ADDENDUM NO. 2

TO: PLANS AND SPECIFICATIONS FOR THE STATE OF MISSOURI

HVAC Improvements
Fulton Reception and Diagnostic Center
Fulton, Missouri
Project No.: C2406-01

A201

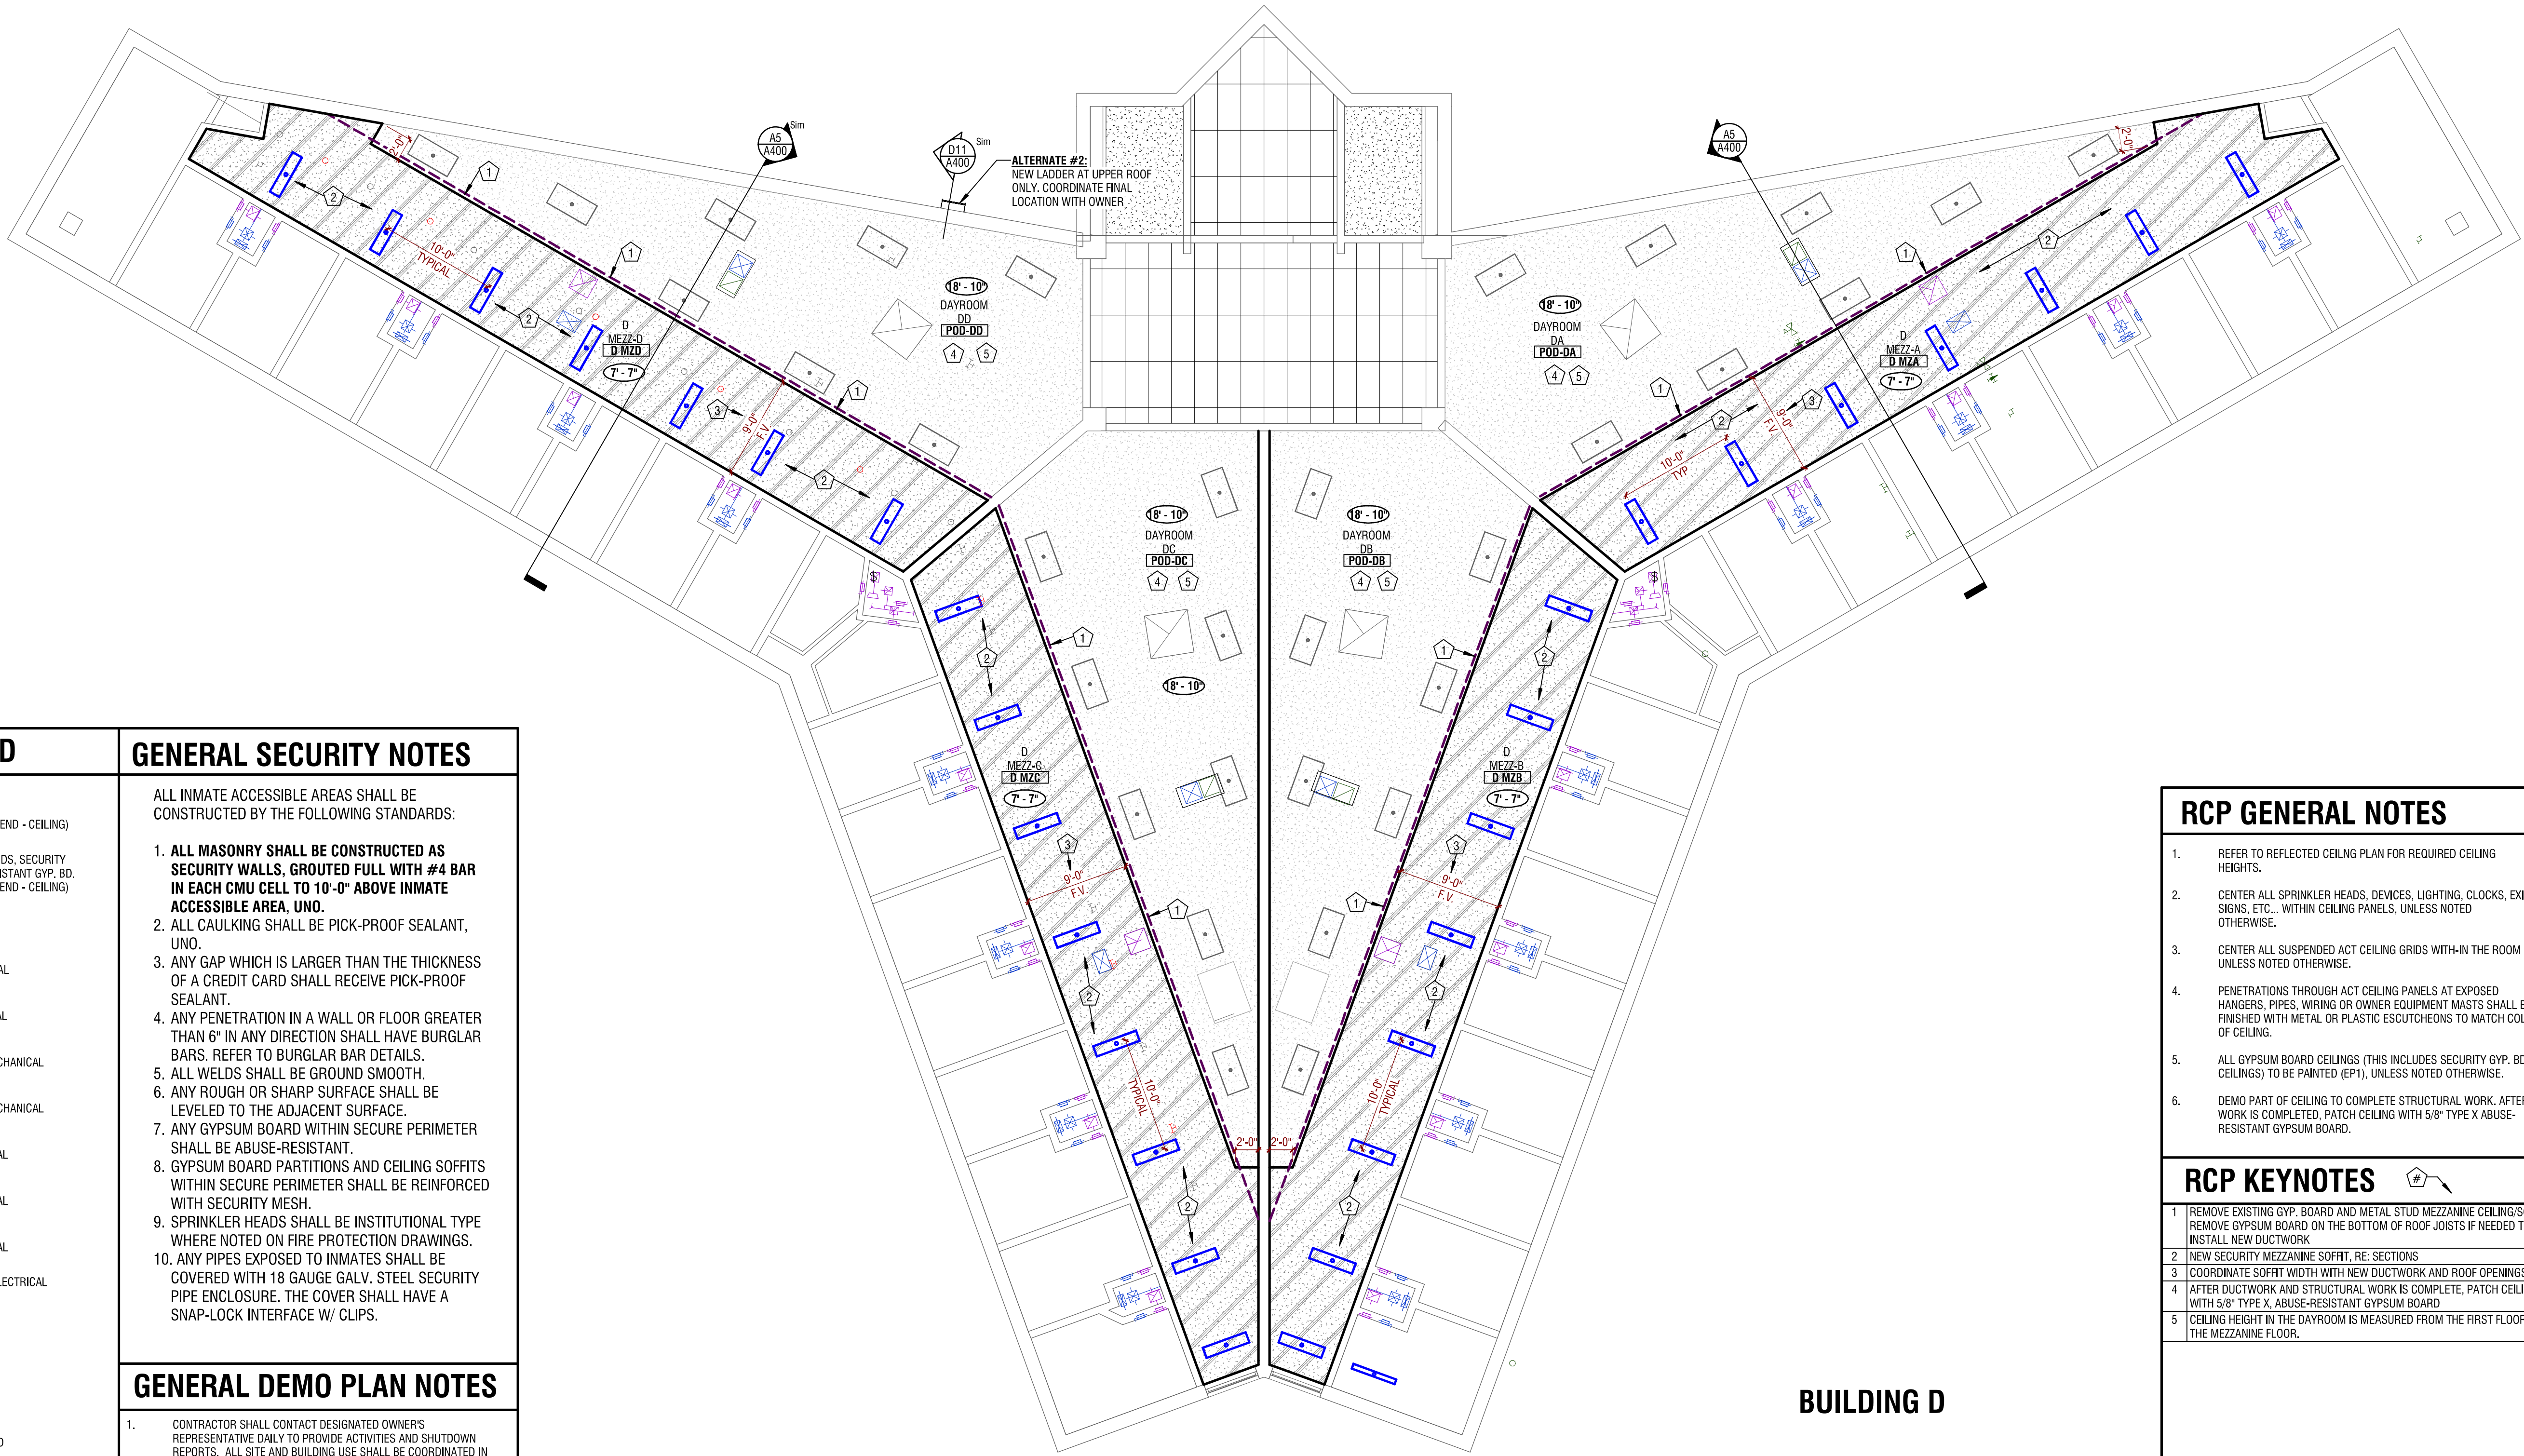
- 1) Materials Legend:
 - a. Revise the Epoxy paint number to match the RCP General Notes.
 - b. Revise the reference to Interior Epoxy Coatings spec section.
